SECTION 4.55 APPLICATION
33 UPPER CLIFFORD AVENUE
LOT C DP 102834 FAIRLIGHT
DA166/2015

S4.55 APPLICATION DRAWING LIST

DEVELOPMENT CONSENT DA-166/2015
NORTHERN BEACHES COUNCIL
DEVELOPMENT MODIFICATION MOD2018/0715
BASIX CERTIFICATE No A336197_03

S4.55 APPLICATION
ADDITIONS & ALTERATIONS
33 UPPER CLIFFORD AVENUE
FAIRLIGHT

Drawing title
LEVEL 1

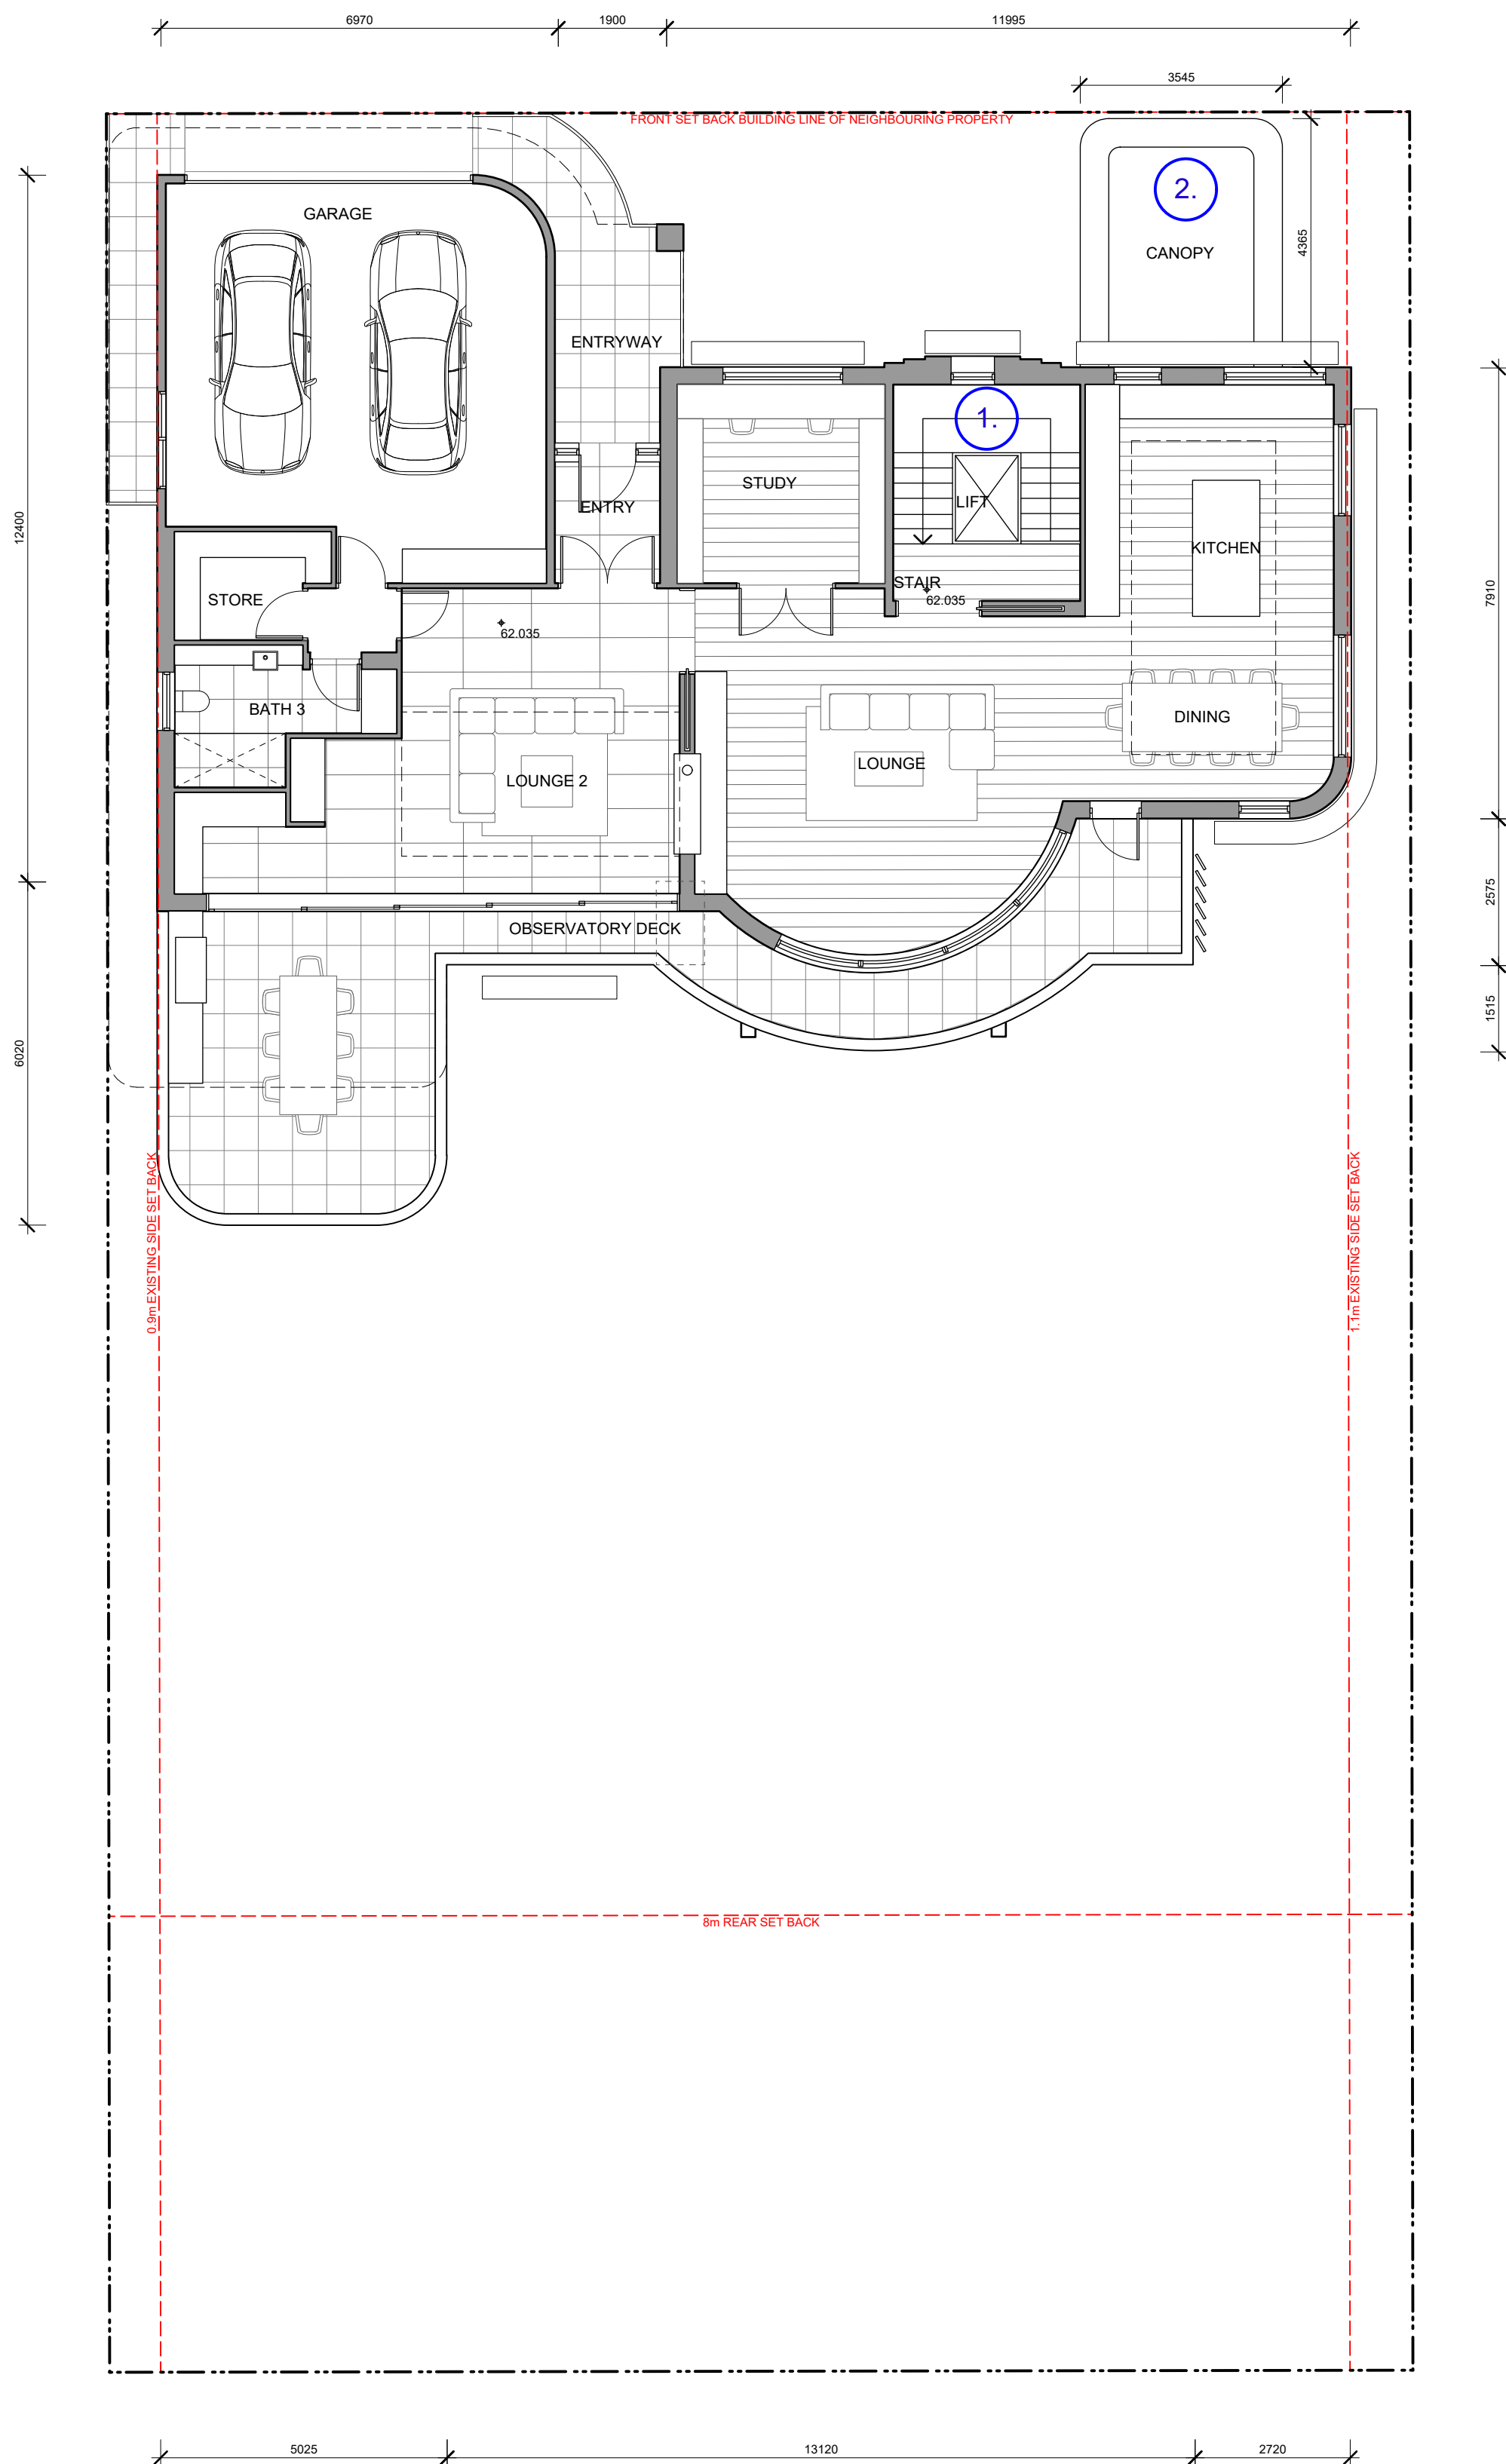
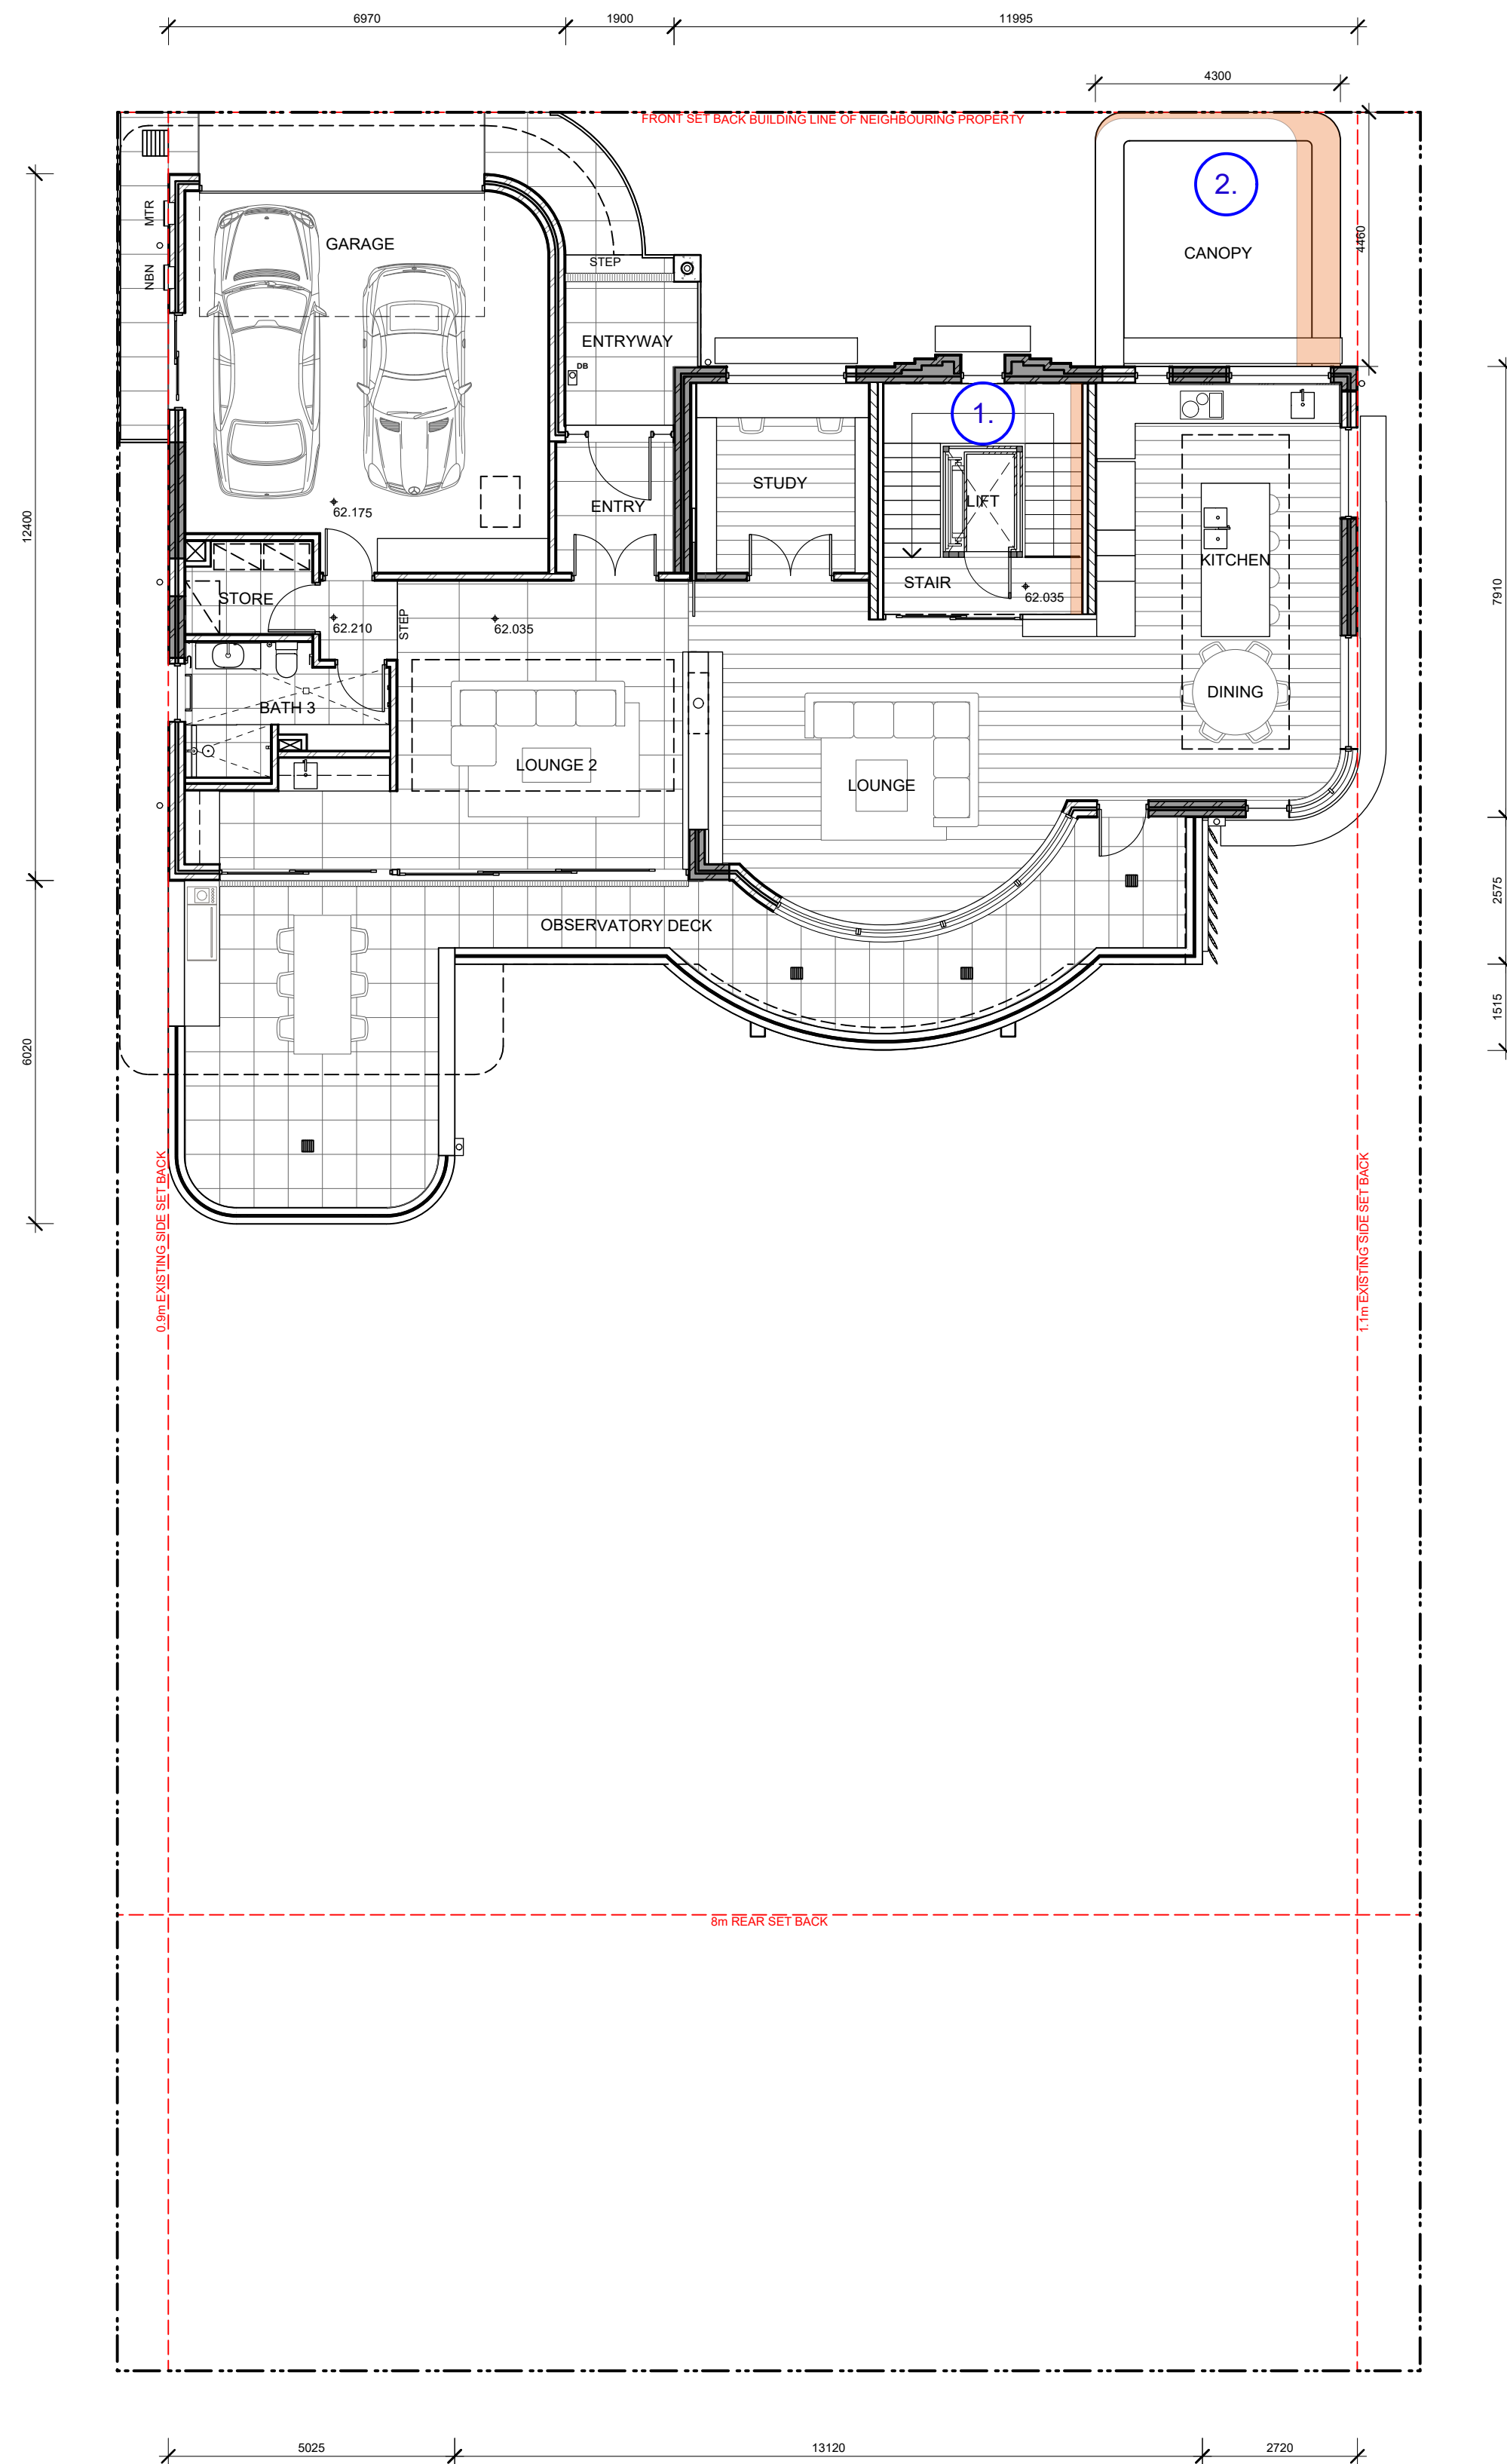
- LEVEL 1
1. REVISED INTERNAL STAIRCASE CONFIGURATION
 2. MINOR INCREASE TO COURTYARD CANOPY
